Rainbow SkyReach (Pty) Ltd

SERVICE BULLETIN

IMPORTANCE	HIGH
AREA AFFECTED	Engine Mount Adapter
SA/B NUMBER	CH 012 06-2019
EFFECTIVE DATE	24 June 2020

Inspection of the four M10 x 30mm bolts that attach the engine mount adapter to the engine mount.

Figure 6 – Engine mount adapter rod

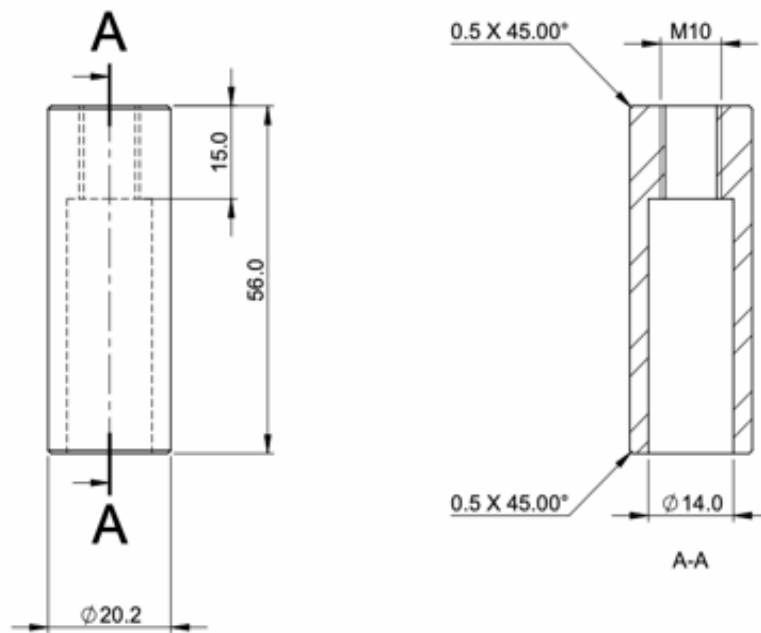
The reason for the bolt bottoming out and not fastening fully is due to a manufacturing defect in the machining of the rod before it gets welded to the rest of the adapter. For clarity a drawing of the rod is provided in Figure 6. The part is manufactured by drilling a $\text{Ø}8.9\text{mm}$ hole through the entire rod. The first 15mm is then threaded, and a larger $\text{Ø}14.0\text{mm}$ hole is machined in from the other side up to where it makes contact with the threaded section. In defective mounts the $\text{Ø}14.0\text{mm}$ hole's depth was incorrect and it does not reach the threaded section, as a result the bolt cannot extend past the 15mm threaded section.

Figure 7 – Bolts requiring inspection

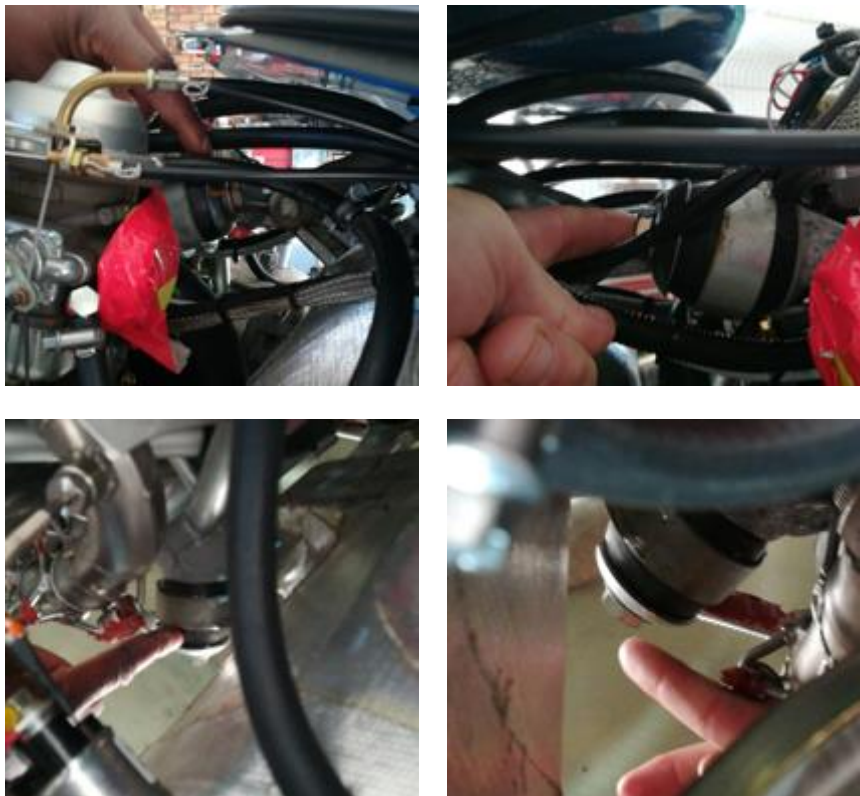
1. All aircraft must be inspected visually by the operator before further flight. Steps 2 and 3 are only symptoms of the problem and if any of those two checks hold true, step 4 will still need to be checked to confirm that a defective engine mount adapter rod is the cause.
2. Check for a noticeable lateral shift in the engine by comparing the location of the front DZUS fasteners to the spinner.
3. Check for the oil filter housing chaffing on the lower oil radiator.
4. Check visually for any of the four engine mount adapter bolts which are not properly fastened, visible threads under the bolt head, as in Figure 4, would indicate that this is the case. The bolts to inspect are shown in Figure 7.

To circumvent the problem a shorter length, Grade 8.8 Zinc Plated M10 bolt may be used which would not extend past the threaded section in the rod and would therefore not bottom out. At the time of publishing this service bulletin it had not been determined whether a M10 x 25mm or a M10 x 20mm would be the best replacement option. The factory will supply the best replacement option at no cost to the operator, we recommend using only approved bolts supplied by the factory since we cannot guarantee that the material and geometrical properties of your local hardware store bolts will be correct.

The two lower bolts may be removed as is, you may just have to remove the lower cowling to gain access to the engine mount. The upper bolts are slightly more complicated since the weight of the engine would need to be fully supported on an appropriate engine hoist before loosening the top bolts.

When inserting the new bolts ensure that the washers (and exhaust plate for the lower mounts) are inserted back in the same order that they were in when removed.
